Planning & Zoning Board

Thursday, November 16, 2023

RE: Richard Holmes; 7305 E. Main Street: Variance Application

Below is the staff review of the above referenced Variance Application.

P:\2307 FRENCH HOUSE\2307 DRAWINGS\2307 A3.1 ELEVATIONS.DGN

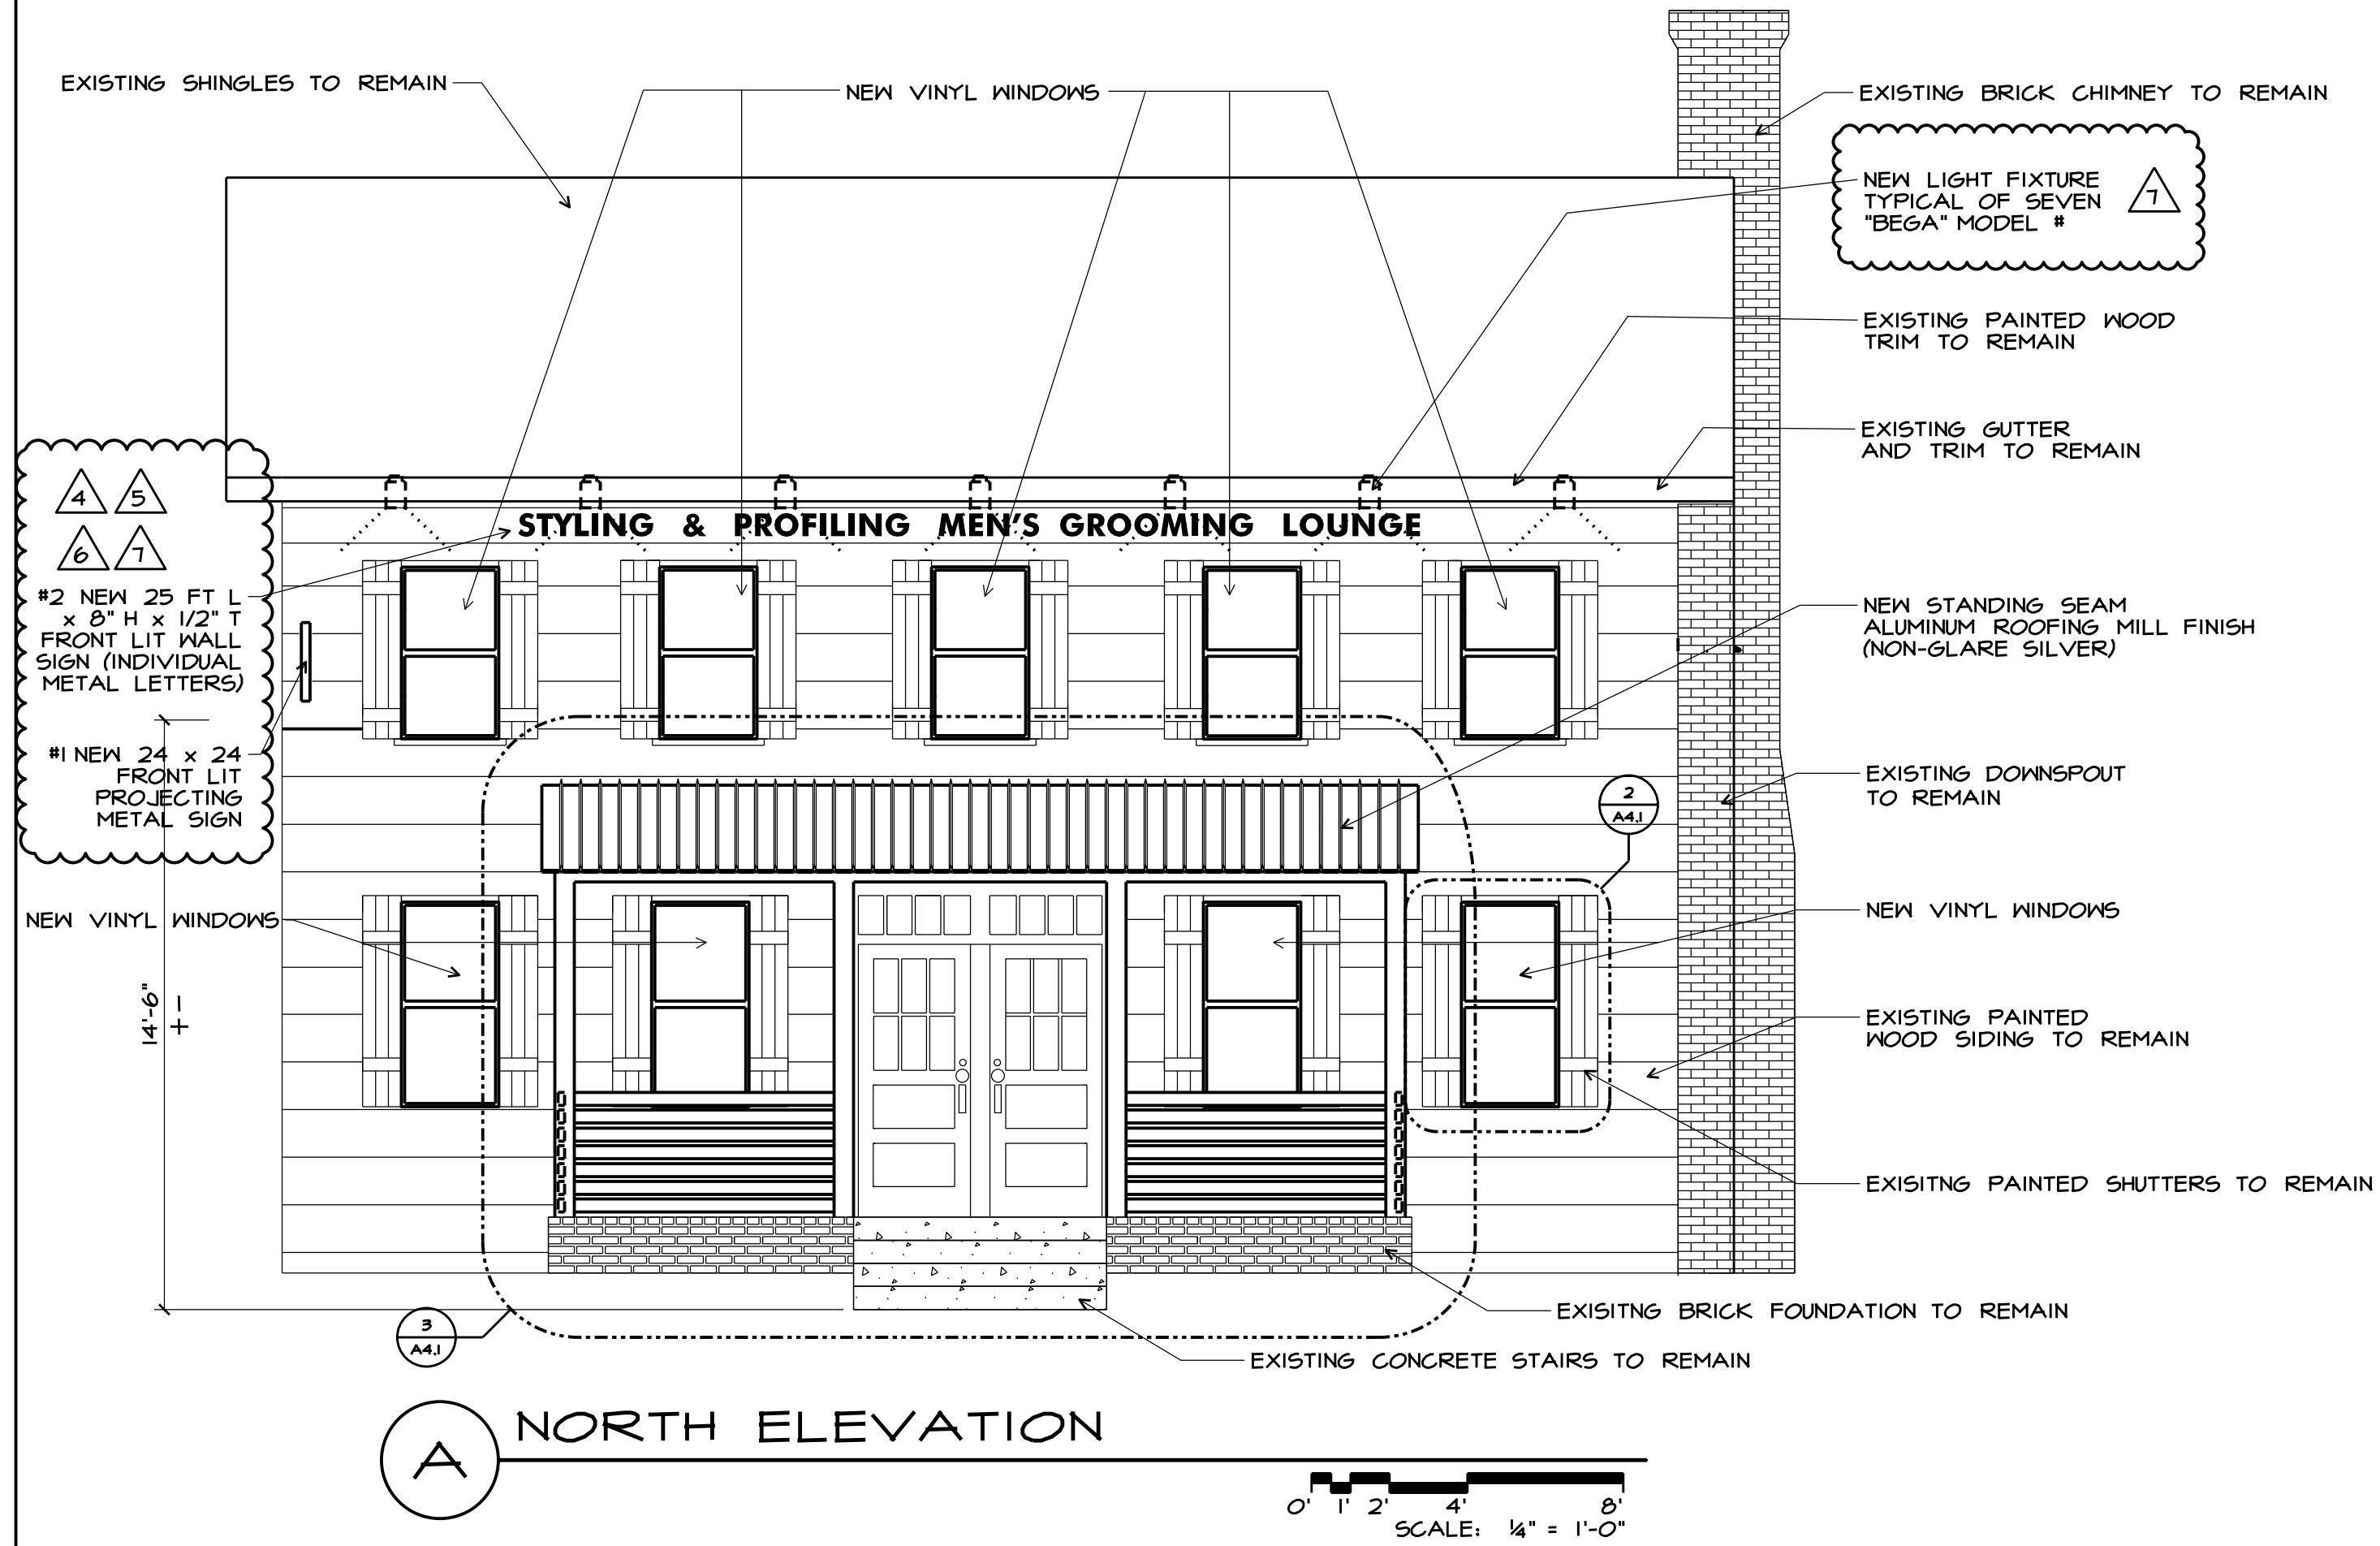
1. The applicant is proposing to have the north elevations wall and projecting sign to be externally illuminated via front lit wall lighting. The zoning code does not call out front lit wall lighting as a permitted type of exterior illumination.

2. The applicant is also proposing to allow the south elevation projecting sign to be internally illuminated. The zoning code does not permit internally illuminated signs in the ORD-C district.

1. The applicant is proposing three (3) signs total, two (2) projecting signs and one (1) wall sign. The zoning code only permits a total of 2 signs on each lot.

1. The applicant is requesting the south elevation projecting sign material of a glass cylinder be permitted. The zoning code only allows projecting signs to be made of wood or metal.

3. Recommendations
 - a. Staff recommends denial of the following variances, Section 1105.03.C.v to permit one additional sign, and Section 1105.03.C.iii to permit internally illumination based on the following reasons:

- ii. The request for internally illuminated signage appears to be a matter of convenience. The applicant does not state in their statement of hardship why the proposed sign is required to be internally illuminated, when it could easily be externally illuminated on the site. Staff is of the opinion granting internal illumination of a sign on the subject site, would set a future precedent to all internal illumination on other properties, when the intent of the zoning code is for external illumination only in the ORD-C zoning district.

- b. Staff recommends approval of the following variances, Section 1105.03.C.v.2 to

permit glass as a permitted projecting sign material, and Section 1105.03.C.iii to permit front lit external illumination based on the following reasons:

- i. The request to allow glass as a permitted projecting sign material is not consistent with the permitted materials found in Section 1105.03.C.v.2, however staff is of the opinion that in this instance, due to the unique nature of the sign, in that is specifically a barber pole, that the material of glass be permitted. Glass is also not a standard sign material generally used for signage, however a barber pole consistently is made of glass, and in and of itself is a unique identifier as a sign. Due to the sign being a barber pole, and the land use being a barbershop, staff would recommend approval of the requested glass material for this specific projecting sign.

- ii. Staff also recommends approval of front lit external lighting for proposed signage on the subject site. The zoning code identifies different types of external illumination, however it does not identify front lit lighting. With the unique architecture of the existing building and location of signage, staff recommends approval of front lit external lighting. Staff is of the opinion that external lighting in the ORD –C zoning district is the intended lighting for this district. That allowing front lit external lighting would be consistent with the intended lighting of the zoning code.
